DESIGN CP DRAWN BY		DART AEROSPACE LTD HAWKESBURY, ONTARIO, CANADA			
CHECKED	APPROVED #	DRAWING NO. D3269	REV. C SHEET 1 OF 1		
DATE 06.06.22	2	BUBBLE WINDOW (R44)	SCALE 1:10		
A	05.02.18	NEW ISSUE			
В	05.03.10	UPDATE MATERIAL SPEC.			
C	06.06.22	NO LONGER TRIMMED

DESIGN	of DRAWN BY	DART AEROSPACE LTD HAWKESBURY, ONTARIO, CANADA			
CHECK	KED APPROVED	DRAWING NO. DSI 9329 SHEET	REV. B		
DATE		TITLE	SCALE		
06.0	06.26	BUBBLE WINDOW INSTALL MOD.	NTS		
A	06.04.25	NEW ISSUE			
В	06.06.26	CHG TO EFFECTIVE AFTER CHG 002	Ŋ

DART SERVICE INSTRUCTION

TO AMEND INSTALLATION INSTRUCTIONS IIN-D044-713 REV. A

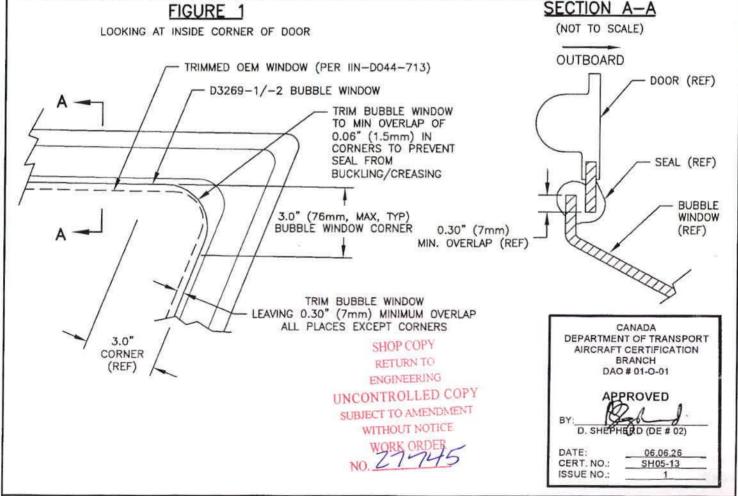
PURPOSE: For the D044-713-013/-014 kits supplied after CHG 002, the D3267-1/-2 bubble windows have been supplied untrimmed to allow for easier installation in the field. The installer must trim the windows in accordance with these instructions prior to installation.

- 1) Modify the R44 crew door per items 3.2.1 and 3.2.2 of Installation Instructions IIN-D044-713 Rev.A.
- 2) Fit and trim the D3269-1/-2 Bubble Window to match the cutout in the door as follows: The bubble window must be a minimum of 0.30" (7mm) larger than the cutout in the OEM window as shown in the figure below. However, in the corners of the window, it is acceptable to trim a 0.06" minimum overlap (1.5mm) to help prevent the D2126-0903 Seal from buckling/creasing in the corners. The edge of the bubble window must be deburred to a smooth finish.
- 3) Continue installing the bubble window per items 3.2.3 through 3.2.5 of the installation instructions
